Access Compliance Report

Public Rights-of-Way

Intersection ID: 10035049	Main Street: PROVIDENCE_RD	Cross Street: N/A	Location: NE
ADA ID: 05E4357757A8	Ramp Type: Perp	Initial Pass/Fail: Fail	Overall Compliance: No
Severity Score: 1.25			
Codes/Mitigation Info/Possible Solution		Field Measurements/Component Compliance

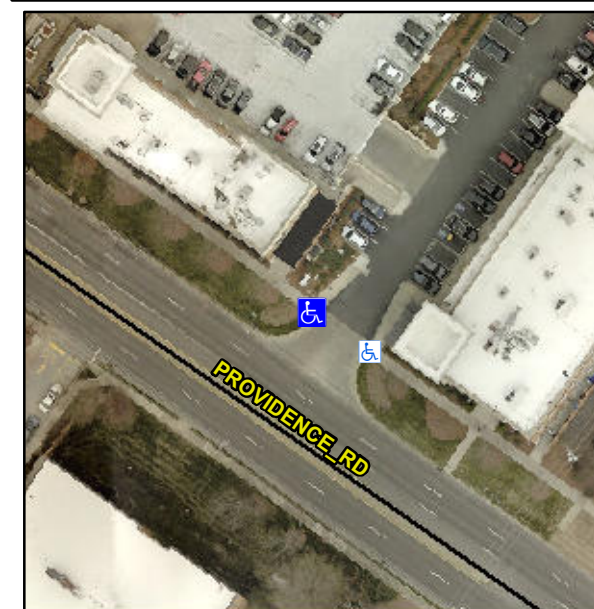
Not Found, R304.5.3

Compliance	Description	Data	Compliance	Description	Data
N/A	Ramp Length (in)	59.0	Yes	Ramp Slope (%)	7.5
Yes	Ramp Width (in)	72.0	No	Ramp XSlope (%)	2.6
N/A	Flare Type LT	N/A	N/A	Flare Type RT	N/A
N/A	Flare Slope LT (%)	N/A	N/A	Flare Slope RT (%)	N/A
N/A	Flare Traversable LT?	N/A	N/A	Flare Traversable RT?	N/A
N/A	Landing Length (in)	N/A	N/A	DWS Provided?	N/A
N/A	Landing Width (in)	N/A	N/A	DWS Contrast?	N/A
N/A	Landing Slope (%)	N/A	N/A	DWS Length (in)	N/A
N/A	Landing X Slope (%)	N/A	N/A	DWS Full Width?	N/A
N/A	Landing Curb? (Y/N)	N/A	N/A	DWS Offset (in)	N/A
N/A	Shared Landing?	N/A			
N/A	Gutter Ponding?	N/A	N/A	Gutter Slope (%)	N/A
N/A	Gutter Lip Ht (in)	N/A	N/A	Gutter X Slope (%)	N/A
N/A	Painted X Walk1?	No	N/A	Painted X Walk2?	N/A
	X Walk 1 Direction	To SE		X Walk 2 Direction	N/A
N/A	X Walk 1 Width (in)	N/A	N/A	X Walk 2 Width (in)	N/A
	X Walk 1 Slope (%)	1.7		X Walk 2 Slope (%)	N/A
	X Walk 1 X Slope (%)	0.8		X Walk 2 X Slope (%)	N/A

Remove & Replace Entire Ramp.
